# CHAPTER 2 – RESPONSES TO COMMENTS

Sections 21091(d) and 21092.5 of the Public Resources Code (PRC) and Section 15088(a) of the CEQA Guidelines govern the lead agency’s requirement to respond to comments provided on a Draft Environmental Impact Report (EIR). Section 15088(a) of the California Environmental Quality Act (CEQA) Guidelines states that “The lead agency shall evaluate comments on environmental issues received from persons who reviewed the draft EIR and shall prepare a written response. The Lead Agency shall respond to comments raising significant environmental issues that were received during the noticed comment period and any extensions and may respond to late comments.” In accordance with these requirements, this chapter provides responses to written comments on the Draft EIR, inclusive of four agency letters received during the public comment period and one agency letter received after the close of the public comment period.

**FIGURE 1 – Concentration of Metals in Artificial Turf Crumb Rubber**  
 Source: [https://www.epa.gov/sites/default/files/2019-08/documents/tc\\_public\\_webinar\\_-\\_august\\_6\\_2019.pdf](https://www.epa.gov/sites/default/files/2019-08/documents/tc_public_webinar_-_august_6_2019.pdf)

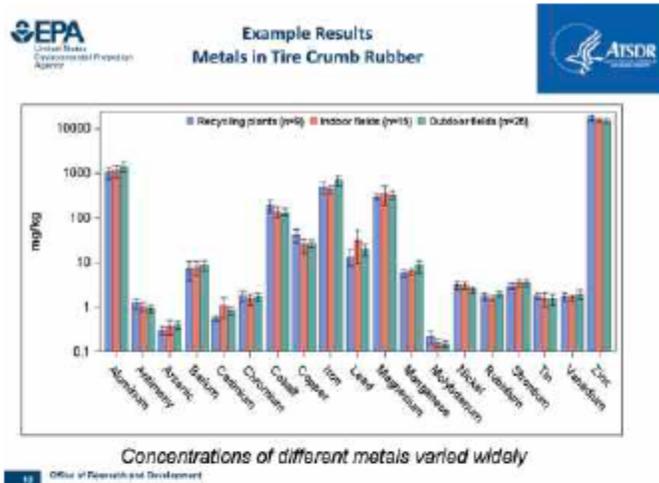
Only the Synthetic Turf Field Recycled Tire Crumb Rubber Characterization Research Final Report: Part 1 -Tire Crumb Rubber Characterization has been completed, to date.<sup>45</sup> The study found:

**FIGURE 2 – PAH Concentrations in Artificial Turf Crumb Rubber**  
 Source: [https://www.epa.gov/sites/default/files/2019-08/documents/tc\\_public\\_webinar\\_-\\_august\\_6\\_2019.pdf](https://www.epa.gov/sites/default/files/2019-08/documents/tc_public_webinar_-_august_6_2019.pdf)

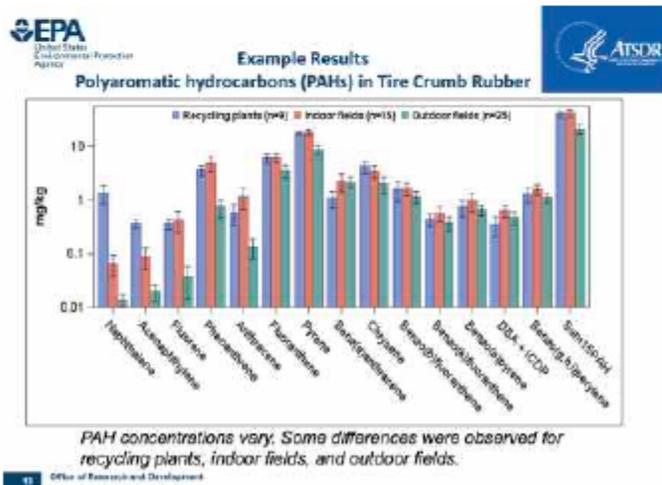
- Most of the target analytes among the 21 metals and 49 SVOCs, and several of the 31 target VOCs, were found in tire crumb rubber collected at fields across the U.S.
- Average concentrations ranged from <1 mg/kg for several metals and extractable SVOCs to up to 15,000 mg/kg for zinc.

**FIGURE 8 – Harvard-Westlake North Faring Road Campus Showing Share of Campus Occupied by Athletic Facilities**

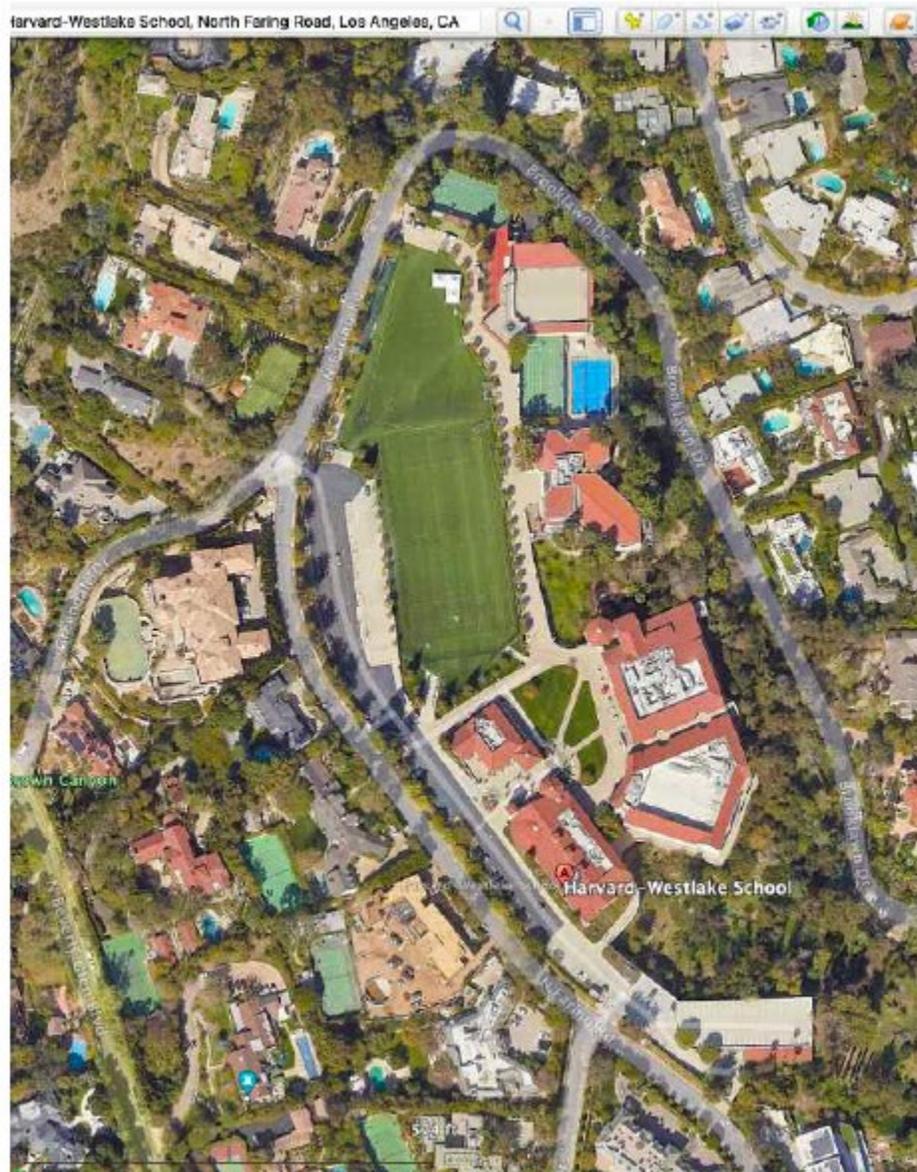
The DEIR fails to identify or adequately address the cumulative and growth-inducing impacts of the proposed Project associated with the transfer of athletic facilities and uses from the two Harvard-Westlake campuses to the Project Site. The proposed Project would free up space on the two existing Harvard [sic]-Westlake campuses currently used for playing fields and other athletic facilities, thus freeing up land that would allow for expansion of academic facilities and thus enrollment expansion on the two campuses. As shown in **Figures 7 and 8**, elimination of athletic fields at the two campuses would free up substantial land area for campus program expansion. The proposed Project would thus be growth-inducing. The DEIR's cumulative impact analysis and growth-inducing impact analyses needs to address the potential of the proposed Project to lead to enrollment expansion and new construction at the two existing campuses, as a result of the transfer of athletic activities to the Project Site. This additional development is a reasonably foreseeable consequence of the proposed Project.

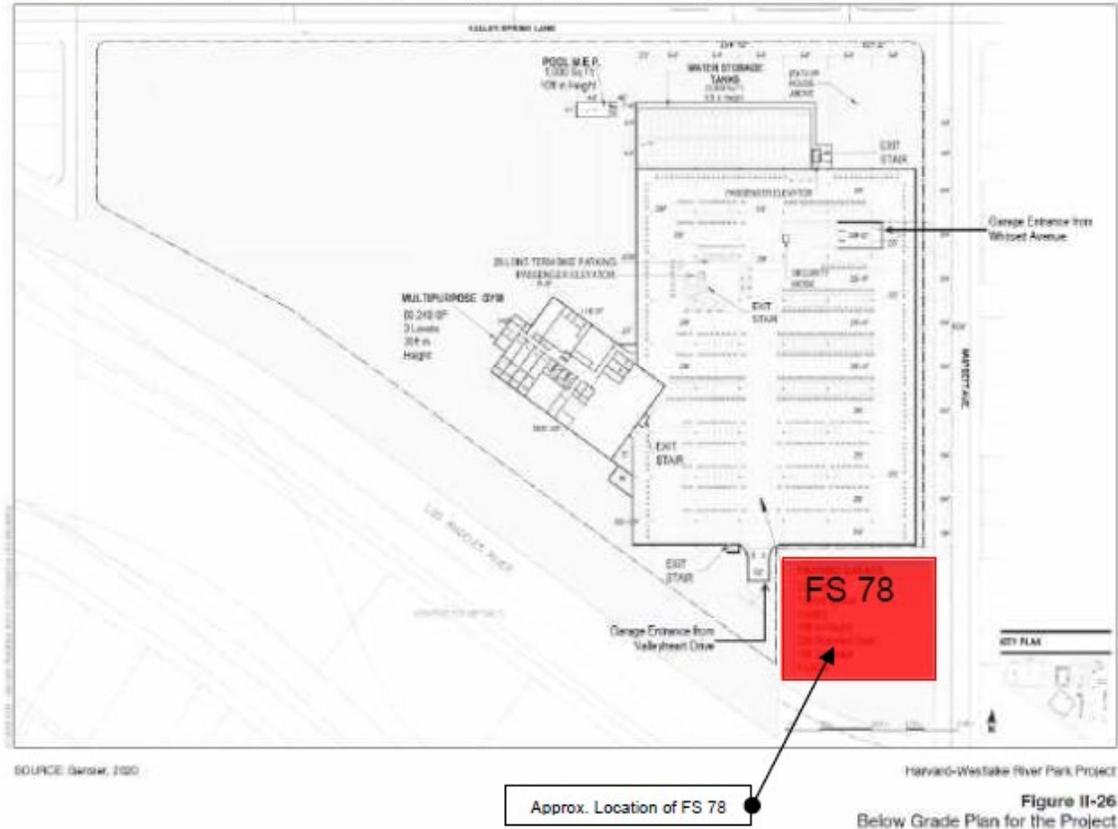
**There is no indication that the proposed internal roundabout would accommodate emergency vehicles. It is unclear how the 29-Parking Space vehicles on the surface lot will exit the proposed facility, since the North Driveway is for subterranean parking lot exit only.**

**Allowing Rideshare service Only into the Southern Driveway will cause confusion and a safety hazard. And, the confusion will further complicate the south driveway relative to the Fire Station 78 access/egress.**

**Visitors not familiar with the specialized proposed parking arrangements having to rely on specialized signs without fair warning will cause confusion and safety hazards.**

Regarding the design and capacity of the roundabout, as stated on page II-53 of the Draft EIR, Section II, *Project Description*, of the Draft EIR, the roundabout is designed to accommodate passenger vehicles, shuttles, garbage trucks, as well as emergency vehicles. The capacity of the roundabout to accommodate turning fire trucks is illustrated in Figure M-3, Fire Truck (NCHRP Report Aerial Fire Truck) Autoturn, in Chapter 3,

*Revisions, Clarifications, and Corrections to the Draft EIR*, of this Final EIR. Figure M-3, which is added to Appendix M, Transportation Assessment, of the Draft EIR, is intended to clarify the adequacy of the turnaround and to supplement the discussion provided in Topical Response No. 10 - Emergency Response. As shown in Figure M-3, the fire engine would be accommodated by the proposed roadway.

**FIGURE 3. MAP OF HISTORICAL RESOURCES WITHIN ONE-MILE RADIUS OF PROJECT SITE**

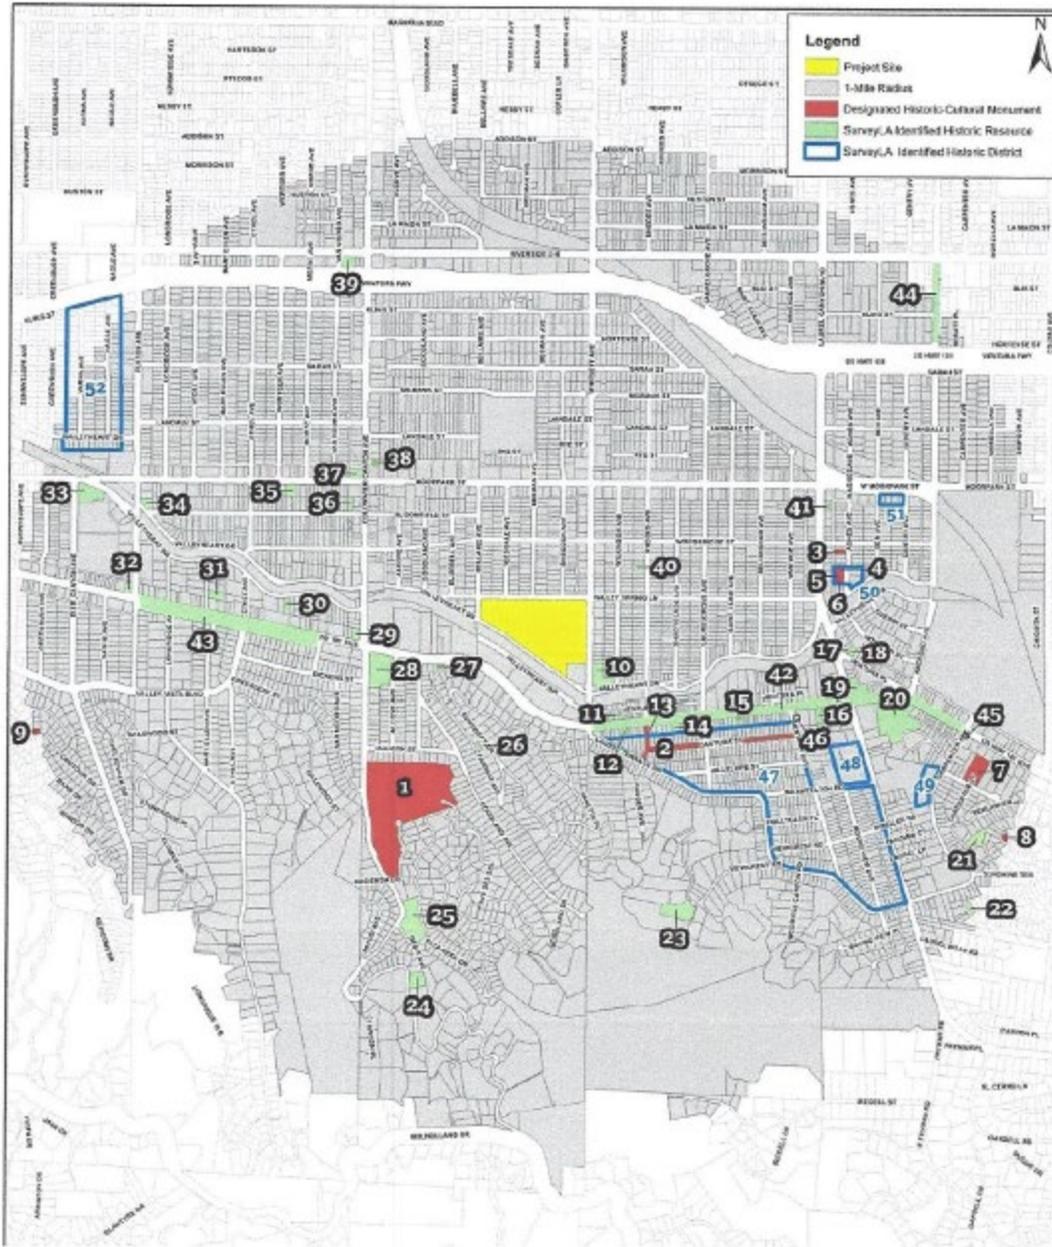
**STUDY AREA:** We request an increase in the size of the Project Study Area. The size of the Project Study Area is inadequate and appears to be measured as a radius of .5 miles from an unmarked center point within this extremely large 17-acre project. This area cannot possibly capture the wide range of severe impacts. This metric disadvantages communities to the east and south of the Project, including hillside residences that receive intensified impacts from light and noise, as well as destruction of views, an esthetic concern. City of Los Angeles has allowed for project study areas of 1 mile, which would be more appropriate for a job of this unprecedented scale, and one that involves an astronomical 250,000 cubic yards of grading. Increasing the Project Study Area would more accurately capture the impacts of grading and hauling along heavily populated streets, as it would include the haul route between the Project and the 101. By confining study to such a tiny area of impact, the environmental review also **fails to capture a great number of sensitive receptors, including elderly and children**, in several nearby neighborhoods, including the Silver Triangle and Sunswept neighborhoods east of Whitsett. Studio City neighborhoods have a very high rate of respiratory disease, which is well documented. Attached is a the HCM map showing a 1-mile radius, page 65 of *Historical Resources Technical Report*. This should be the area of study for **all DEIR categories**, including air quality, transportation.

**ADDENDUM 03 – WEDDINGTON GOLF AND TENNIS PARK POTENTIAL IMPROVEMENTS FOR SHARED FACILITIES**

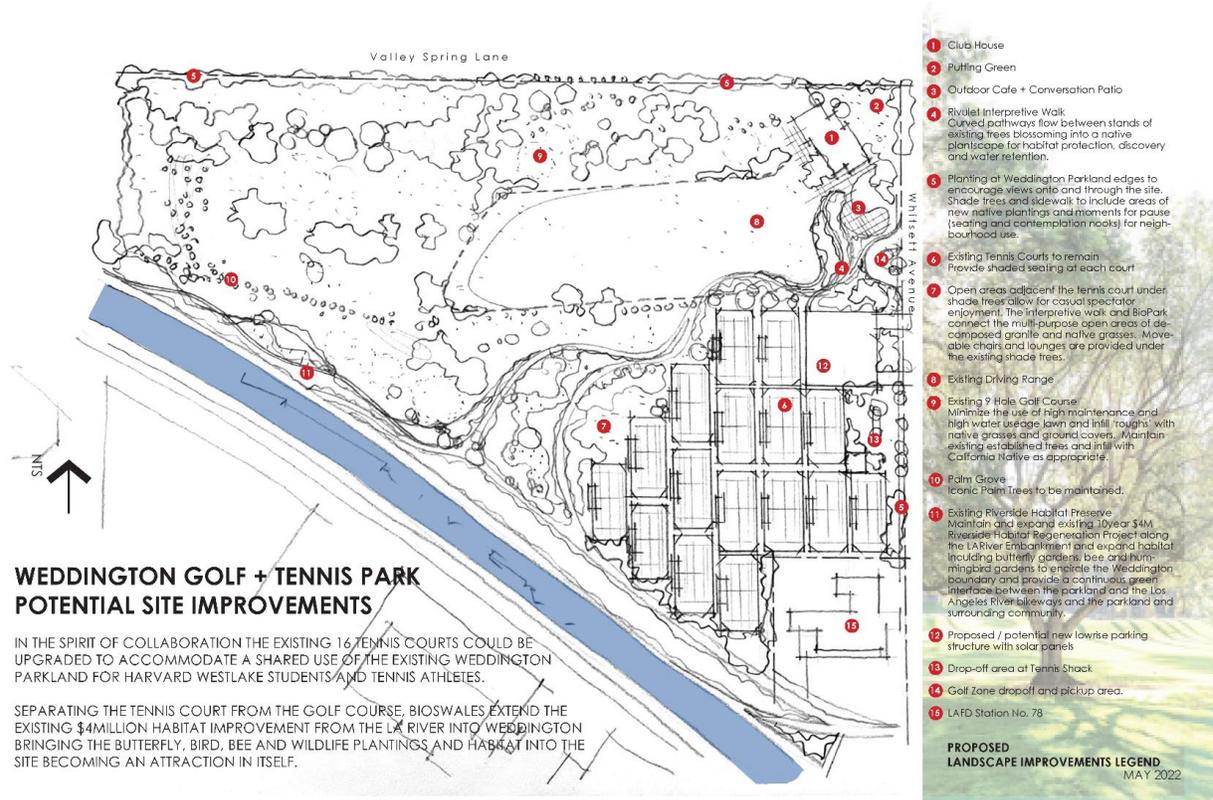
This comment suggests potential site improvements, including the provision of upgrading the 16 existing tennis courts and shared use of the tennis courts between the School and the general public. Note that as discussed in Topical Response No. 11 – Recreation: Golf and Tennis Facilities, recreational opportunities would be available to the public with Project implementation, including shared use of eight (8) proposed tennis courts.

However, this suggested alternative would not meet the underlying purpose of the Project to supplement the School's athletic and recreational facilities, and would not provide Harvard-Westlake School a campus that can fulfill its educational mission and athletic principles now and in the future. This alternative would not include new athletic fields, a gymnasium, and pool, which are recreational facilities that are in line with the underlying purpose of the Project and consistent with the Project Objectives (see pages II-13 and II-14) of the Draft EIR.
